Access Compliance Report

Public Rights-of-Way

(Curb Ramps)

Intersection ID: 30183	Main Street: HIDDEN_CREEK_DR	Cross Street: VALLEYDALE_RD	Location: S
ADA ID: 181654741775	Ramp Type: Perp	Initial Pass/Fail: Fail	Overall Compliance: No
Severity Score: 25			
Codes/Mitigation Info/Possible Solution		Field Measurements/Component Compliance

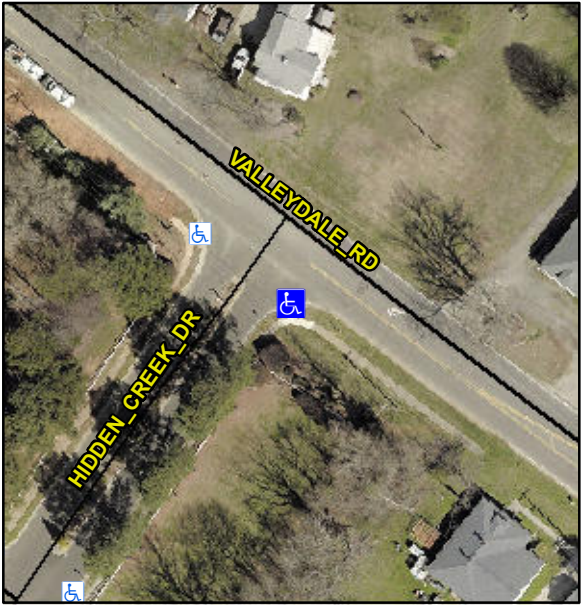
Possible Solutions:						
	Remove & Replace Entire Ramp.						
	Surveyor Notes:						
	N/A						
	PROW/ADA:						
	R304.2.2						
	Street 1 Name	HIDDEN CREEK DR					
	Stop Condition-Street 2	StopSign					
	Street 2 Name	N/A					
	Stop Condition-Street 1	N/A					
Total Cost:		\$	1850.00				
				Compliance	Description	Data	Compliance
						Description	Data
				N/A	Ramp Length (in)	53.0	No
				Yes	Ramp Width (in)	55.0	Yes
				N/A	Flare Type LT	N/A	N/A
				N/A	Flare Slope LT (%)	N/A	N/A
				N/A	Flare Traversable LT?	N/A	N/A
				N/A	Flare Traversable RT?	N/A	N/A
				N/A	Landing Length (in)	N/A	N/A
				N/A	Landing Width (in)	N/A	N/A
				N/A	Landing Slope (%)	N/A	N/A
				N/A	Landing X Slope (%)	N/A	N/A
				N/A	Landing Curb? (Y/N)	N/A	N/A
				N/A	Shared Landing?	N/A	N/A
				N/A	Gutter Ponding?	N/A	N/A
				N/A	Gutter Lip Ht (in)	0.5	N/A
				N/A	Painted X Walk1?	No	N/A
					X Walk 1 Direction	To NW	
				N/A	X Walk 1 Width (in)	N/A	N/A
